IDAPA 39 – IDAHO TRANSPORTATION DEPARTMENT

39.03.41 – Rules Governing Traffic Control Devices

39.03.41 – RULES GOVERNING TRAFFIC CONTROL DEVICES

Figure 2B-33. Slow And Move Over For Stopped Vehicles With Flashing Lights Sign

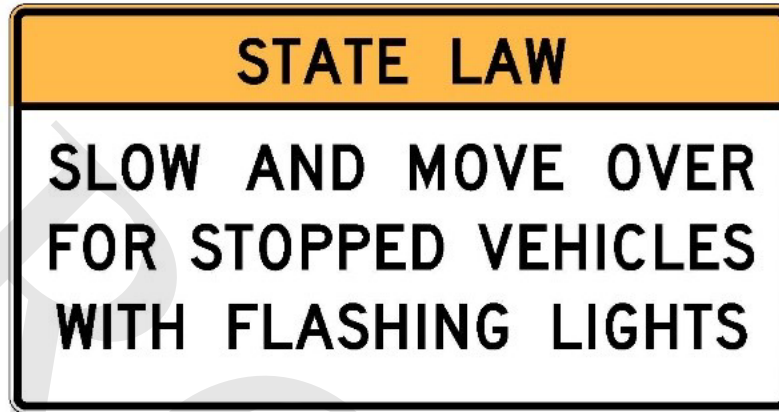
08. Figure 2B-33. Slow and Move Over for Stopped Vehicles with Flashing Lights Sign. On page 102, add the following figure:

07. Section 2B.69, SLOW AND MOVE OVER FOR STOPPED VEHICLES WITH FLASHING LIGHTS (R16-101) sign. On page 102, add the following section:

Support:
01 State law requires drivers approaching stationary police, emergency, tow truck, or highway incident response vehicles to slow on two-lane highways and to slow and move over on multi-lane highways.

Option:
02 The SLOW AND MOVE OVER FOR STOPPED VEHICLES WITH FLASHING LIGHTS (R16-101) sign (see Figure 2B-33) may be used to inform road users of the state law on multi-lane highways.

Standard:
03 If used, the SLOW AND MOVE OVER FOR STOPPED VEHICLES WITH FLASHING LIGHTS sign shall only be used on highways with two or more lanes in each direction.

Option:
04 The legend STATE LAW may be displayed at the top of the SLOW AND MOVE OVER FOR STOPPED VEHICLES WITH FLASHING LIGHTS sign.

Standard:
05 If used, the legend STATE LAW shall be black with a black border on a yellow background.
